工程指示 / 要求簡箋(E.I.)

工程指示編號：EI / 9488 / 18

工程名稱：觀塘裕民坊

工程項目：試模窗大圖修改 (T1及T3)

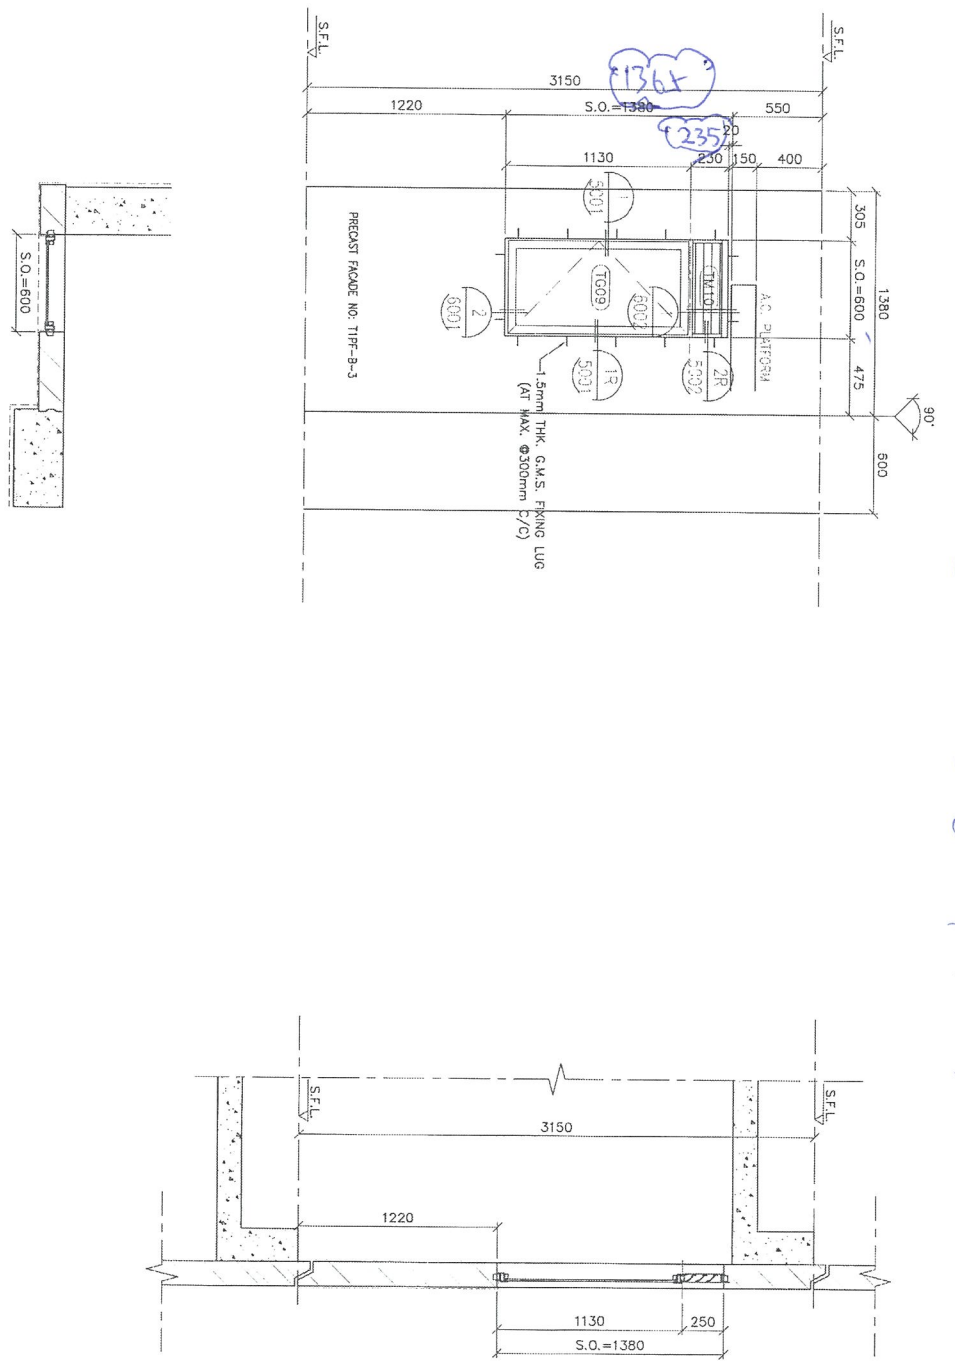
此窗按則師評需修改尺寸後，跟TIM/M-1一樣，所以球型窗取借此窗 (TIM/B-2)

取內成模窗

已check 原尺寸只有此窗

如附件所示，現確定修改 T1W/B-1，取消 T1W/B-2 的試模窗，以及拆圖須註明 T3W/D-5 及 T3W/D-6 的試模窗"待定"

WINDOW MARK	T3W D-5
SECTION :	50mm ALUM. SECTION
QTY :	1 NOS. (TYPICAL)
LOCATION :	T3 S2/F FLAT D KITCHEN
3-GLAZING	8mm THK CLEAR TEMPERED GLASS
REMARK :

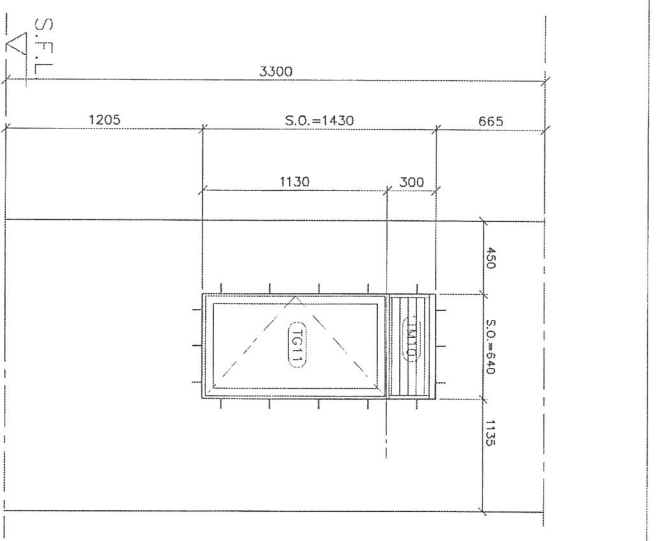
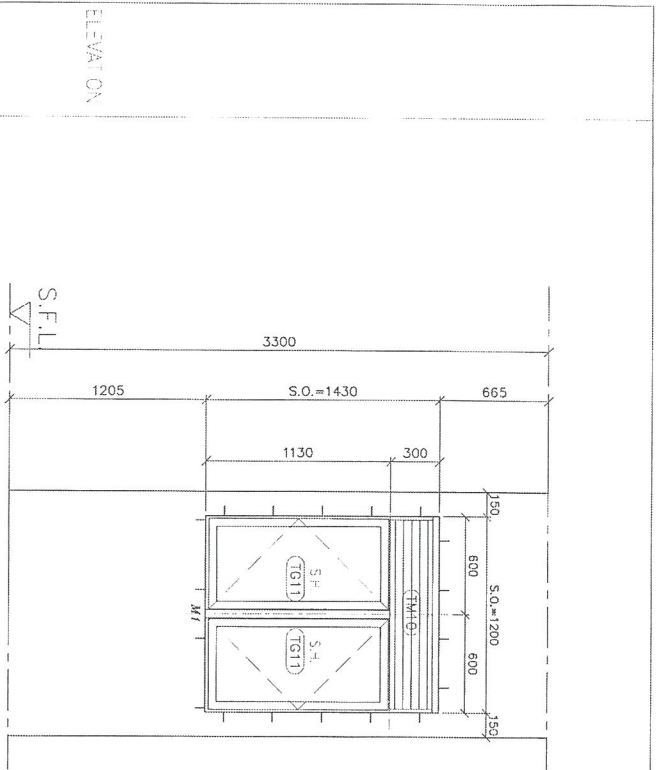
此兩款窗跟須提供試裝窗圖紙，但圖尺寸待確定，  
 構圖上須註明“待定”
